Item 4.**Modification Application: 905 South Dowling Street, Zetland - D/2023/724/B****File Number:** D/2023/724/B**Summary**

Date of Submission:	2 April 2025 Amended drawings were received on 15 April 2025.
Applicant/ Owner:	Karimbla Properties (No 60) Pty Ltd
Architect:	Mako Architecture
Developer:	Meriton
Cost of Works:	\$506,521,727.80
Zoning:	The site is zoned MU1 - Mixed Use under the Sydney Local Environmental Plan 2012.
Proposal Summary:	This is a Section 4.55(1A) modification seeking to amend the concept consent as it relates to the Stage 2 North-Western site and Stage 3 Southern site, as follows: • Modify Condition 2 - Approved Development to reflect the amended concept drawings; • Insert a new Condition 2A requiring amended drawings to be submitted; • Modify Condition 6 - Floor Space Ratio to redistribute residential and non-residential floor space (within the maximum permitted); • Modify Condition 13 - Security Gates to allow for an exception within Building S2; and • Modify Condition 20 - Deep Soil to redistribute deep soil across the site.

Figure 8: Approved Building H envelope (left) compared to the proposed Building H envelope (right), with a reduction of the 3m western setback proposed

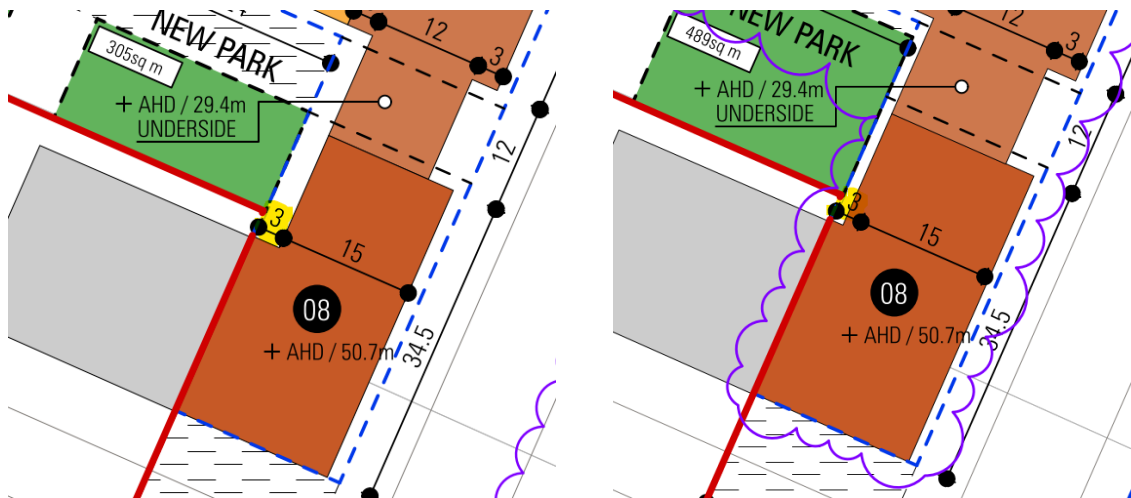
29. As per point (h) above in relation to Building H, the concept plan includes an increase in building depth, resulting in a reduction in the 3m western setback, as shown in Figure 8 below.

30. The reduction to the 3m western setback is not supported, nor is it required by the detailed design DA which achieves the 3m setback. A condition of consent is recommended that requires the concept plan to be updated to reinstate the 3m setback.

Figure 9: Approved solar zone (left) compared to the amended solar zone (right)

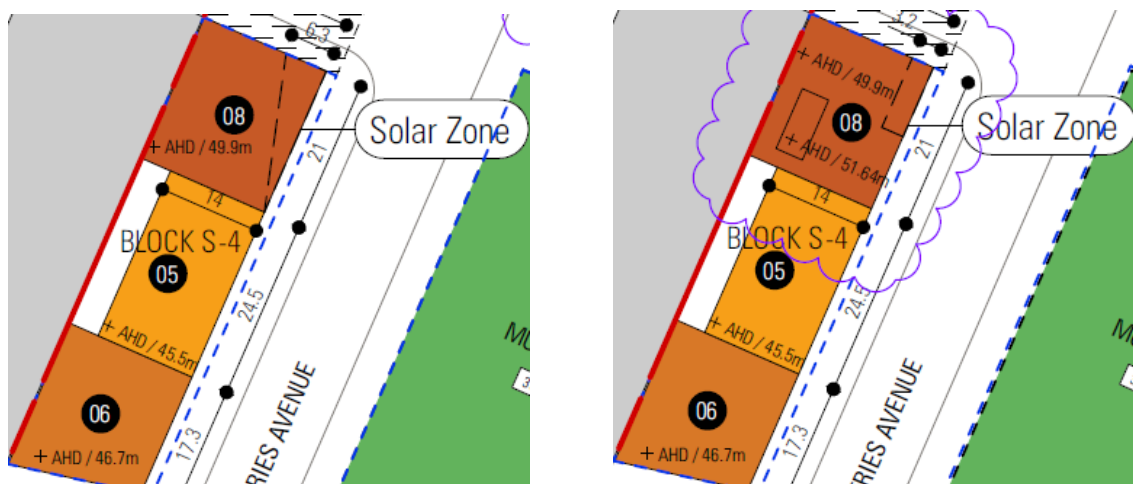
34. The application proposes to amend the design of the 'Solar Zone' on Building S4.

35. The concept drawings state that the 'Solar Zone' is an area that may be occupied only subject to:
- achieving ADG solar access compliance for Block S-4, and
 - achieving 75% 4 hours' solar access to Mulgu Park (June 21).
36. It is noted that part of the built form of Building S4 occupied the original solar zone and no built form is proposed within the amended solar zone. The proposed amendment ensures that the detailed design DA is consistent with the concept DA.
37. The amended solar zone is acceptable as the overall Stage 3 South development achieves 69% solar access which is a marginal non-compliance with the 70% design criteria of the ADG. The proposal also achieves 4 hours of solar access to 75% of Mulgu Park at midwinter.
